SOUTH MARSTON
PARISH COUNCIL

SMPC response to S/COND/23/0848 Revised HHT Phasing Plan

3.8.2023

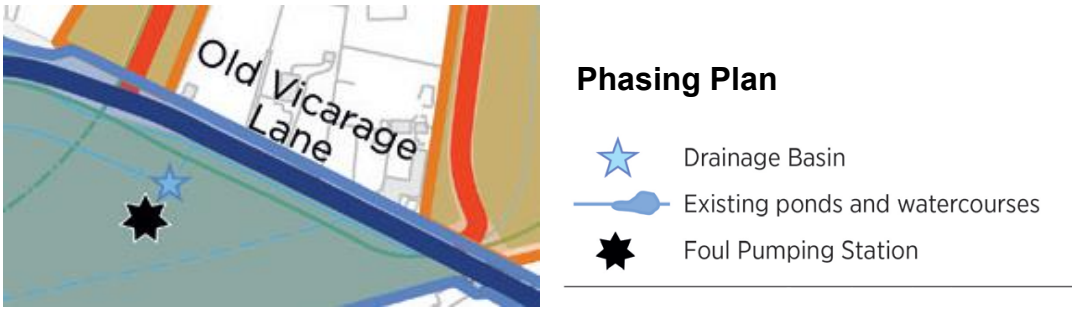
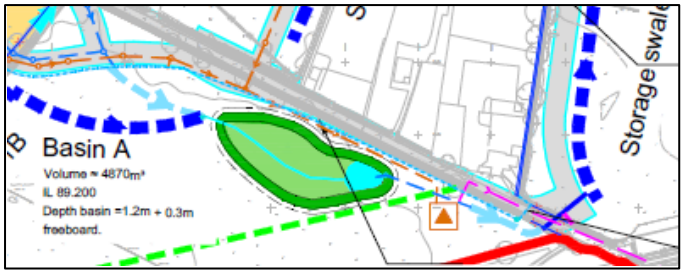
Para 2.5 of the Phasing Plan requires details of the disposal of sewage for that parcel as part of the overall foul drainage strategy. We note the proximity in the Phasing Plan map of the pumping station to the main SUDs drainage 'Basin A' which receives the overwhelming majority of surface water flow from South Marston.

This is a different arrangement than that shown in the Foul Water Management Plan approved in 2022 and reproduced in the draft Brookbanks Surface Water Drainage layout plan Jan 2022 reproduced here. We hope the Phasing Plan will be corrected in line with the Foul Water Management Plan

Notwithstanding the above, we are concerned that the foul water pumping station for South Marston expansion is located very close to the planned Basin A, given the latter's importance. The same area is also close to that earmarked for use in the construction phase for the OVL/ Primary Street junction (CEMPMS plan submitted July 2022), in particular arrangement for disposal of silt etc. Para 3.1 of the CEMP states '*There will be no discharge of foul or contaminated drainage from the site into either groundwater or any surface waters, whether direct or via soakaways'.*
